# Draft Remedial Investigation Report

## Technical Review Comments Newtown Creek

### Remedial Investigation/Feasibility Study

#### Dated November 2016

**Figure 1 USEPA NSR ranges, FMRM NSR calibration targets, and proposed NSR calibration targets. Note, proposed EPA NSR calibration targets may differ from NCG analysis presented in Attachment G-H due to differences in analytical methodology.**

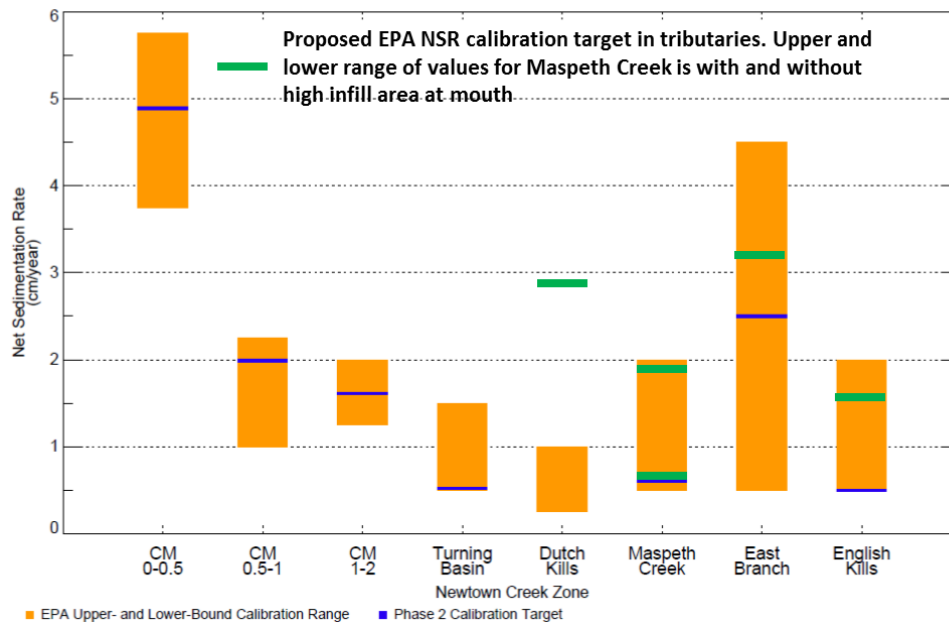
- c. Page 94, Second Paragraph, Figure G5-46, and Table G5-9: Explain the rationale behind the choice of NSR calibration targets using different approaches in various portions of the study area. The NSR calibration targets appear to have been defined using a number of somewhat inconsistent approaches. For instance, NSR calibration targets in the main stem were defined using 1991-2012 bathymetric differencing, East Branch and Maspeth Creek using 1999-2012 bathymetric differencing, and English Kills using the lower bound of USEPA-proposed NSR ranges despite the availability of 1999-2012 bathymetric differencing. In addition, explain why a NSR calibration target is not defined for Dutch Kills despite the availability of 1999 bathymetry data as well as USEPA-proposed NSR ranges.

- d. Page 94, Second Paragraph, Figure G5-46, and Table G5-9: As mentioned in the comments to Attachment G-H, the 1999 bathymetry data may likely be biased in English Kills and the East Branch and therefore unsuitable to establish NSR calibration metrics. In contrast, the 1991-2012 NSR is consistent with the other lines of evidence for NSRs in these tributaries. Within Maspeth Creek, barring an area of high sedimentation near the mouth (Area 2 in Table G-H-3), the 1991-2012 and 1999-2012 bathymetric differencing produce relatively similar NSRs as other lines of evidence. Therefore, it is appropriate to use the 1991-2012 bathymetric differencing to define calibration targets in Maspeth Creek (primarily for portions away from the mouth; NSRs shown in Table G-H-3), resulting in calibration targets within the USEPA NSR ranges for this tributary. Finally, in Dutch Kills, which was not covered in the 1991 survey, the 1999-2012 bathymetric differencing indicates NSRs relatively similar to other lines of evidence (adjusted for uncertainty in Pb-210 NSRs). However, the NSR calibration target calculated using the 1999-2012 bathymetric differencing is higher than the upper bound of the USEPA NSR ranges for this tributary. Figure 1 shows a graphical comparison of the USEPA NSR ranges, the FMRM NSR calibration targets, and proposed EPA NSR calibration targets. The proposed revisions to the NSR calibration targets also represents a more consistent use of datasets than the approach in the FMRM which uses 1999-2012 bathymetric differencing in two tributaries, the lower bound from USEPA's NSR ranges in another tributary, and no calibration target in the fourth tributary. The proposed approach relies on the 1991-2012 bathymetric differencing in three tributaries, using the 1999-2012 bathymetric differencing in the fourth tributary solely due to a lack of bathymetric coverage in 1991. Furthermore, the proposed NSR calibration targets are also consistent with the NSRs from other lines of evidence. Perform a comparative analysis of NSRs from multiple lines of evidence as a data quality check on the NSRs from individual approaches, and develop a consistent approach for defining NSR calibration targets in the various tributaries.

This analysis for reconciling NSRs from various lines of evidence suggests that the 1991-2012 bathymetric differencing is appropriate to define NSR calibration targets in English Kills, East Branch, and Maspeth Creek. The resulting NSR calibration targets are also within the USEPA NSR ranges for these tributaries. Within Dutch Kills, due to the lack of bathymetry data from 1991 and because the 1999-2012 NSRs are consistent with other lines of evidence, the 1999-2012 bathymetric differencing is appropriate to define NSR calibration targets. However, the resulting NSR calibration target is higher than the upper bound in USEPA's NSR range for this tributary. The proposed revisions to the NSR calibration targets for these tributaries also represents a more consistent use of datasets than the approach in the FMRM which uses 1999-2012 bathymetric differencing in two tributaries, the lower bound from USEPA's NSR ranges in another tributary, and no calibration target in the fourth tributary. The proposed approach relies on the 1991-2012 bathymetric differencing in three tributaries, using the 1999-2012 bathymetric differencing in the fourth tributary solely due to a lack of bathymetric coverage in 1991.

**Figure 2. Probabilistic comparison of depth-average TSS measurements during flood and during ebb using measurements during Phase 1 and Phase 2. Data from the vicinity of CM ~0.25**

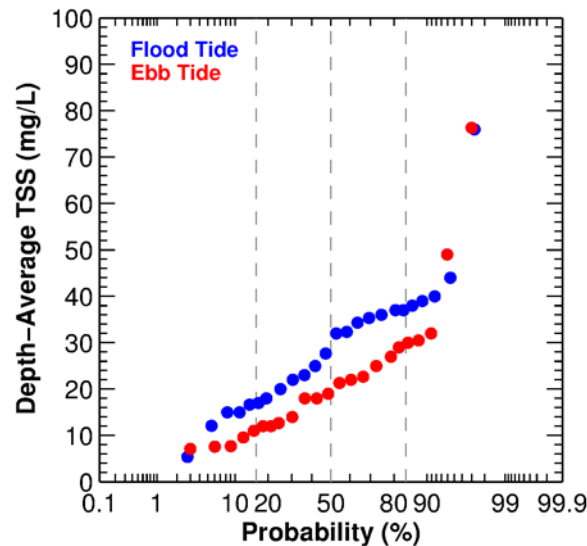
The relative distribution of the flocculated clays/silts and wash load fractions can potentially be determined by reviewing available data – for instance, as shown in Figure 2, median depth-average TSS concentrations during the flood and ebb phases of the tide correspond to approximately 30 mg/L and 20 mg/L, respectively, in the vicinity of CM 0.25.

This relative difference between flood and ebb provides an approximate idea of the relative proportions of the fast-settling and slow-settling classes.

**Figure 3. Spatial profile of settling velocity estimated from sediment trap data at selected locations relative to model inputs for settling velocity.**

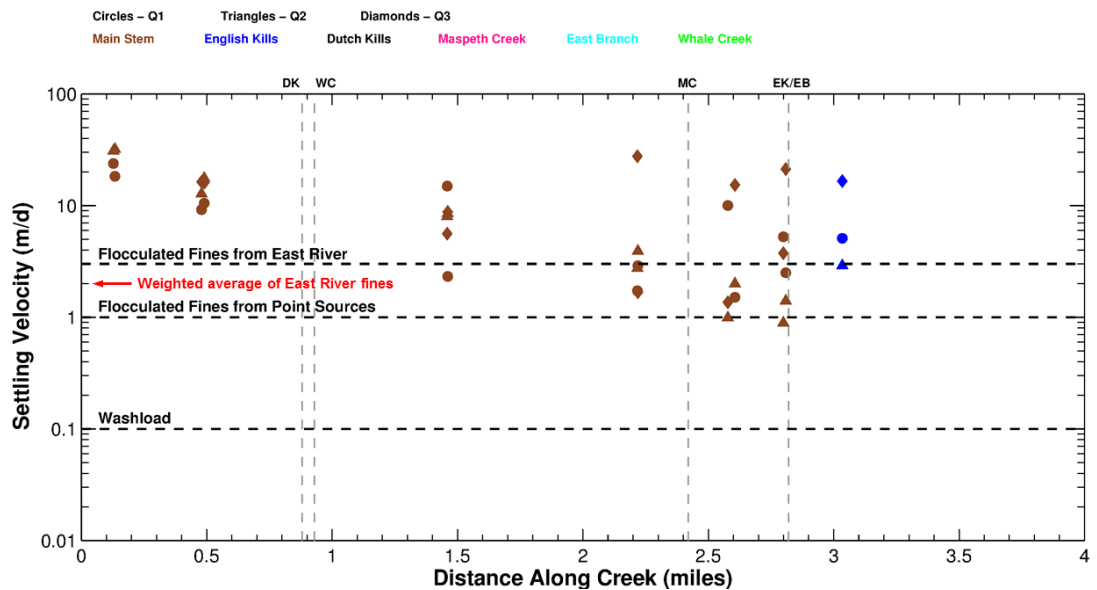
- i. Page 94, Fourth Paragraph: The calibrated settling velocity for the flocculated clays/silts from East River and from point sources at 3 and 1 m/d are about 10X too low compared to estimates from within Newtown Creek and compared to other studies of NY harbor (LBG et al., 2014; HydroQual, 2007; Ralston et al., 2013; Fugate and Chant, 2006). In particular, Fugate and Chant (2006), sampling the CSO plume from an outfall in Flushing Bay, NY, estimated settling velocity for CSO solids ranging from 43 m/d to 800 m/d, with a median value of 250 m/d. The sediment transport model developed by Moffatt & Nichol and Deltares for the Lower Passaic River and Newark Bay Superfund sites (currently under final review by US EPA Region 2) also uses fine sediment settling velocities up to an order of magnitude higher than used in the FMRM. In addition, site-specific estimates within Newtown Creek have been derived using the gross sedimentation rates measured in the sediment traps (data shown in Figure G5-7). These data were paired with the fines content measured for the sediment accumulated in these traps, median near-bottom TSS from Phase 1 and Phase 2 measurements in the vicinity of the traps, and an average spring-neap probability of deposition at the trap locations (assuming critical shear stress for deposition of 1 dyne/cm<sup>2</sup> and the Krone formulation for probability of deposition). The calculations were performed for various locations along the main stem and a location within lower English Kills. Since the sediment traps measure gross sedimentation rates, the settling velocity estimated using this approach is an estimate of the gross settling velocity, a number directly comparable to model inputs for this parameter. Figure 3 shows the results of this analysis in comparison to model inputs (horizontal dashed lines). The comparison shows

that barring a few instances in the vicinity of the Turning Basin, the majority of the estimated settling velocity values are higher (up to 10X) than model inputs for flocculated fines from East River as well as point sources.

Reconcile model inputs for settling velocities with these site-specific estimates.

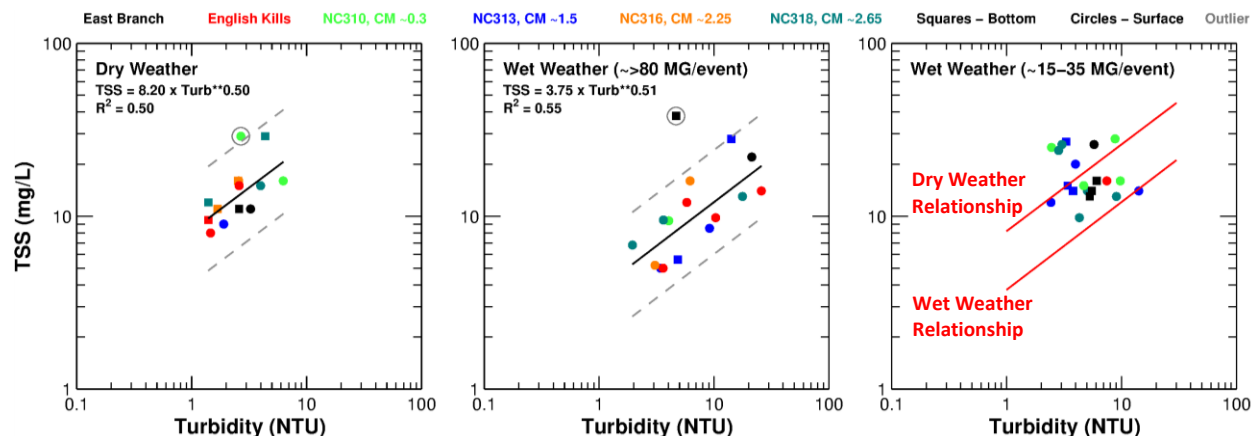
- b. Page 1, Third Paragraph: EPA has reviewed the data used to develop the bulkhead sonde turbidity-TSS correlations shown in Figures G-F-1, G-F-3, G-F-5, G-F-7, G-F-9, and G-F-11. The analysis focused on identifying the sources of variability in the turbidity-TSS relationships. The two major sources of variability include fouling of the turbidity sensors, and differences in the depth sampled by the turbidity sensor and the TSS water sample collection depth. In addition, a smaller subset of water samples also likely include location artifacts, where the water samples were collected in locations with total water depths somewhat different than at the sonde locations.

Excluding the data affected by the afore-mentioned sources of variability, the turbidity-TSS relationships primarily appear to be a function of the environmental conditions, as seen in Figure 4. The dry-weather relationship includes data from the August 2014 and October 2014 sampling events, and the large (>~80 MG/event) wet weather relationship includes data from the December 2014 and August 2015 sampling events. Data from the remaining events (March 2015, April 2015, and September 2015) consist of relatively smaller wet weather events (~15-35 MG/event). The total point source discharges during these events were estimated using the point source flow input files provided with the FMRM model. The coefficient of determination ( $R^2$ ) for the dry-weather and large wet-weather relationships are 0.50 and 0.55, respectively. This may partly be due to the fact that variability due to differences in the TSS sampling depth and sensor depths was only reduced (by excluding TSS samples collected at depths more than 3’ apart, in the vertical, from the turbidity sensor) but not eliminated entirely. Nonetheless, the individual TSS values are within a +/- 2X envelope around the turbidity-TSS regressions, which is typical for such relationships.

Comparison of the dry-weather and wet-weather relationships shows an apparent increase in turbidity in the entire study area during large wet-weather events. This appears consistent with various aerial images of the study area, which show somewhat more turbid water originating from the tributaries, especially during wet-weather events. An increase in turbidity would also be conceptually consistent with (1) point source discharge events during such conditions, with a higher dissolved organic matter loadings expected from CSO releases than water originating from the East River, and (2) with additional solids loadings from point source releases. Due to the relatively large variability in the turbidity-TSS pairs, a turbidity-TSS relationship was not derived for the smaller wet-weather events (~15-35 MG/event). Nonetheless, it is worth noting that the majority of the turbidity-TSS pairs fall in between the dry-weather and large wet-weather relationships. This is conceptually consistent with the hypothesis of relatively more turbid water associated with point source discharges; releases during the smaller point source discharge events would be subject to relatively more dilution with East River water than during larger events and thus show lesser impacts on turbidity than during large wet weather events.

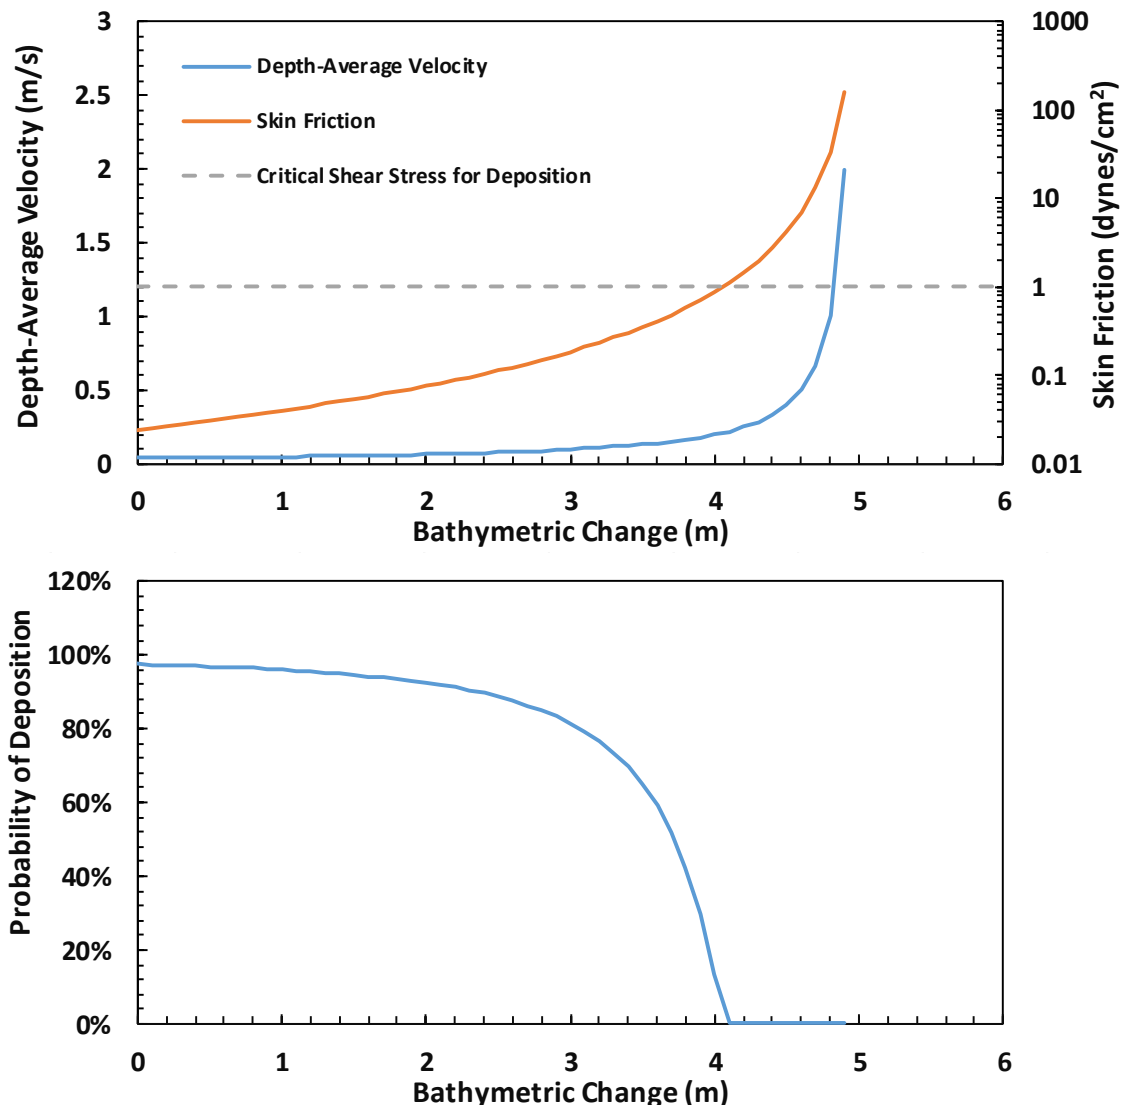
The evaluation of NSRs based on Cs-137 and Pb-210 activity in Section 1.3 proposes historical changes in the sediment loadings from point sources as an explanation for the higher NSRs based on Cs-137 than Pb-210. However, no other lines of evidence (e.g., historical measurements or estimates of point source flows & suspended sediment concentrations, changes in the watershed, point source controls, etc.) are provided in support of the argument of a temporal change in point source sediment loads.

From a conceptual standpoint, there are two constraints on the process of sedimentation – sediment supply and trapping efficiency, with the resulting sedimentation rate a positive function of both constraints. The arguments in Section 1.3 focus only on a hypothesized change in historical point source sediment loadings as an explanation for the temporal decline in sedimentation rate noted in some of the geochronology cores. This process is fairly straightforward – for a given trapping efficiency, sedimentation rate over a given area will be direct function of the sediment loading rate. The limitation of trapping efficiency on sedimentation rate over time can be conceptualized using the approximate geomorphic feedback method used in the FMRM model (described in Section 5.3.4 of Appendix G). For a given flow rate passing a given location in the system, as water depth decreases with sedimentation, velocity increases due to the reduction in cross-sectional area, thus increasing bed shear stress. The increase in bed shear stress causes a decrease in the probability of deposition (calculated using Eq. G-J-7), a parameter linearly related to the sedimentation rate. Therefore, as water depth decreases with increasing sedimentation at a given location, the probability of deposition decreases, thus reducing trapping efficiency, and therefore sedimentation rate. This process is shown graphically, for an arbitrary cross-section with a constant flow rate of  $2 \text{ m}^3/\text{s}$ , constant cross-section width of 10 m, initial depth of 5 m, D90 of 1400  $\mu\text{m}$ , and critical shear stress for deposition of  $1 \text{ dyne}/\text{cm}^2$ . With increasing sedimentation (manifest as bathymetric change), flow velocity increases as shown in the upper panel due to a decrease in water depth. This causes an increase in the skin friction at the bed-water interface (also shown in the upper panel). Using the Krone formulation for probability of deposition (one of the commonly used formulations), as shown in the lower panel, the probability of deposition decreases with increasing skin friction (i.e., increasing sedimentation or decreasing water depth). At a bathymetric change of  $\sim 4.1 \text{ m}$  (corresponding to water depth of 0.9 m), the skin friction becomes equal to the critical shear stress for deposition at which point the probability of deposition reduces to 0 and sedimentation ceases. In other words, the probability of deposition (which is a surrogate for the trapping efficiency) is in a state of dynamic equilibrium with the ongoing sedimentation. This imposes a natural upper limit on the sedimentation that can be achieved in a tidal system such as Newtown Creek. Therefore, the potential for changes in sedimentation rate due to a temporal change in sediment loadings as well as changes in trapping efficiency are to be considered when evaluating data that exhibit temporal changes in sedimentation rate.

Figure 6. Geochronology NSRs relative to 2012 bathymetry at geochronology core locations.

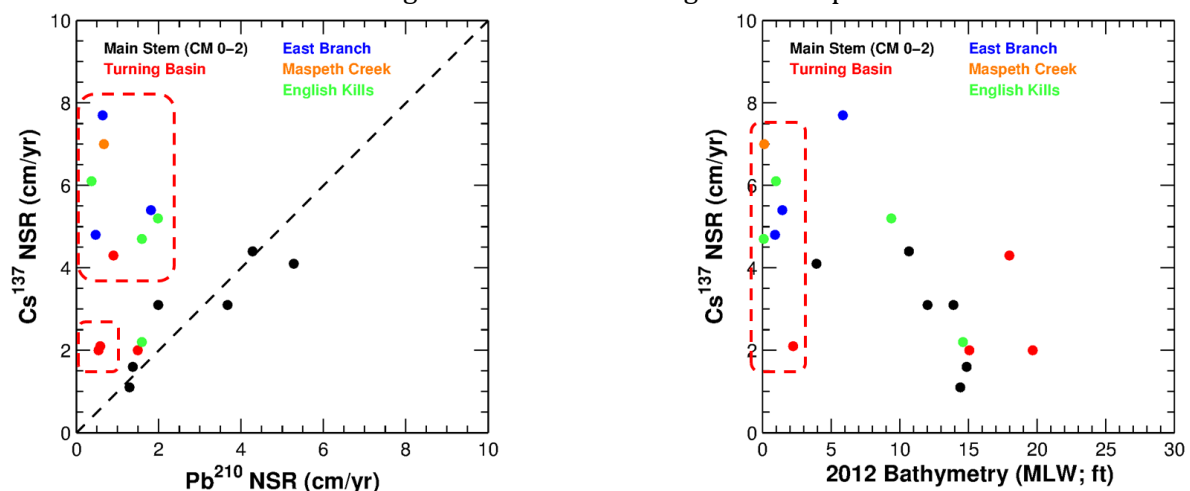
The geochronology core dataset includes eighteen cores where both cesium-based and lead-based NSRs were calculated. Figure 6 shows the cesium-based versus lead-based NSRs for these cores (left panel), and the cesium-based NSRs versus the 2012 bathymetry at the core locations (right panel). Eight cores (seven in the main stem and one in English Kills) have lead-based NSRs that are similar (within a factor of two) to the cesium-based NSRs. This suggests no temporal changes in sedimentation occurred at these locations, and therefore no changes in sediment supply or trapping efficiency. Review of the remaining ten cores (with cesium-based NSRs more than a factor of two higher than lead-based NSR) relative to the 2012 NCG bathymetry at the core locations suggests that sedimentation rate in a majority of these cores may currently be limited by trapping efficiency. For six of these cores (mostly located within the tributaries), the current bathymetry is relatively shallow and within ~2 ft of Mean Low Water (MLW) levels. Using the cesium-based NSR indicates that in the 1960s, these locations would have been 3 ft to 11 ft deeper than currently. Therefore, a

decrease in trapping efficiency may be an equally plausible explanation for the decreasing temporal trend of NSRs in these cores as changes in sediment loadings from the point sources.

The remaining 4 cores (with cesium-based NSRs more than a factor of two higher than lead-based NSR), do not appear to be limited by trapping efficiency based on water depth. However, there may be additional historical changes that may have caused a change in shear stress regime and therefore the trapping efficiency and resulting sedimentation rate. For instance, review of NOAA's navigation charts (shown in Figure 7) along with the dredging history (Section 1.4 in Attachment G-H) of Maspeth Creek shows that even though a navigation channel was dredged in this tributary in the

1930s (to 20 ft below MLW), as seen in the upper left panel in Figure 7, it had infilled significantly by the 1950s. Between 1952 and 1974, the sedimentation rate is on the order of  $\sim 10$  cm/year. This rapid sedimentation may reflect a change in the shear stress regime due to a decrease in navigation activities (propeller wash can cause a local increase in the shear stress regime thus reducing trapping efficiency) in this tributary sometime between the 1930s and 1952. Since 1974, due to the relatively shallow depths in much of the tributary, sedimentation rate inferred from these navigation charts is on the order of  $\sim 1$  cm/yr, likely limited by trapping efficiency, due to the relatively shallow water depths. It is also worth noting that the sedimentation rates inferred from these navigation charts is within the range of NSRs calculated from geochronology (both Cs-137 and Pb-210) in this tributary, with the cesium-based NSR approximately ten times higher than the lead-based NSR.

**Figure 8 Probabilistic comparison of net sedimentation rate from various lines of evidence.**

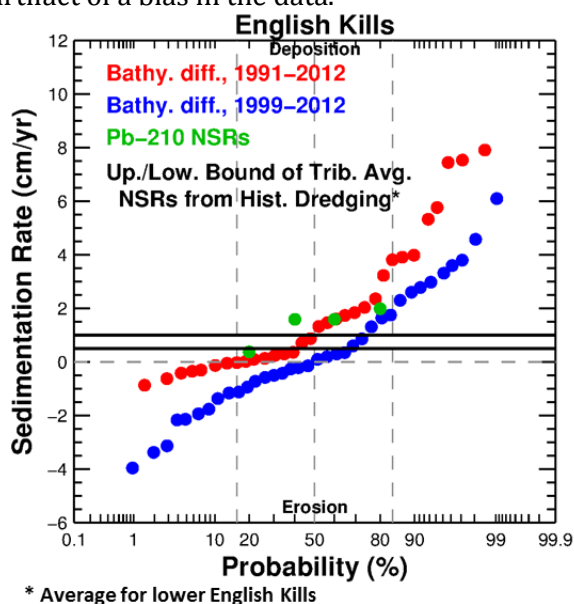
1. Several analyses related to NSRs using bathymetric data are presented in this attachment. However, in some cases, the findings are not explored in detail. For instance, although the 1991-2012 bathymetric comparison shows mostly sedimentation in the tributaries, the 1999-2012 bathymetric comparison shows erosion over approximately half the area in English Kills and in part of the East Branch (Area 5 in Figure G-H-12). However, these patterns of erosion have not been evaluated from a data quality perspective, i.e. is the pattern of erosion real and explainable given the known forcings in the system (e.g., hydrodynamics, navigation impacts, etc.), or is the pattern of erosion an artifact of a bias in the data.

Figure 8 shows a probabilistic comparison of NSRs in English Kills and represents the results of an analysis to reconcile NSRs from various lines of evidence, assess data quality, and evaluate the erosional signal noted in English Kills during 1999-2012. The NSRs from bathymetric comparison were developed by calculating the difference between the 1991/1999 single-beam bathymetry and the 2012 multi-beam bathymetry at the corresponding locations, with each of the red and blue symbols in Figure 8 representing the average NSR calculated for given single-beam transect. NSRs based on the Pb-210 cores collected in the English Kills are included with green symbols. The upper- and lower-bound estimates of NSR based on historical dredging records (shown in Figure G-H-56) is also included with horizontal black lines.

Figure 8 shows that more than ~50% of the transects show erosion during 1999-2012, whereas only approximately 15% of the transects show erosion during 1991-2012. Spatially, the erosional signal during 1999-2012 is distributed within specific areas within English Kills – Figure G-H-10 shows a consistent pattern of erosion in the southern half of the cross-section in lower English Kills (Areas 3 and 4 shown in Figure G-H-6). In some locations, erosion of up to 6' is calculated over the 1999-2012 period. Comparing the 1991-1999 surveys implies significant sedimentation in these same areas, up to 9' in some cases. The spatially continuous pattern of erosion suggests a distinct signal that is either real or the result of some artifact in the data. However, even if said accumulation from 1991-1999 was explainable (for argument's sake), the erosion signal cannot be explained given the known hydrodynamic and anthropogenic forcings (primarily navigation which is relatively negligible in this tributary at approximately 1 vessel/month). Nor can the erosion signal be attributed to analytical/sampling variability in the 1999 single-beam bathymetry data – such variability would be expected to manifest itself as randomly distributed in space rather than being spatially coherent. Furthermore, all 4 cores with Pb-210 based NSRs were collected in areas where erosion is noted in the 1999-2012 bathymetric comparison. The signal of erosion in the 1999-2012 bathymetric comparison and sedimentation in the Pb-210 dating (which reflects the sedimentation rate over the preceding 10- to 20-year time-horizon, approximately the same time-frame as the 1999-2012 bathymetric comparison) is mutually inconsistent. Furthermore, reviewing the NSRs based on 1991-2012 bathymetric differencing relative to the range of Pb-210 NSRs shows ~50% overlap between the two. In contrast, the Pb-210 NSRs overlap with only roughly 15% of the 1999-2012 bathymetric differencing distribution. In addition, the tributary-average NSR based on historical dredging records is very close to the median NSR based on 1991-2012 bathymetric differencing. These comparisons of NSRs based on 1991-2012 bathymetric differencing, Pb-210, and historical dredging suggests consistency between these various lines of evidence in English Kills and provides confidence in these NSRs. In contrast, the 1999-2012 bathymetric differencing appears to be an outlier, showing erosion that cannot be explained given known forcings, and is inconsistent with the Pb-210 and historical dredging NSRs. Therefore, the 1999-2012 bathymetric comparison may likely be unreliable, possibly due to artifacts in the 1999 bathymetric survey.
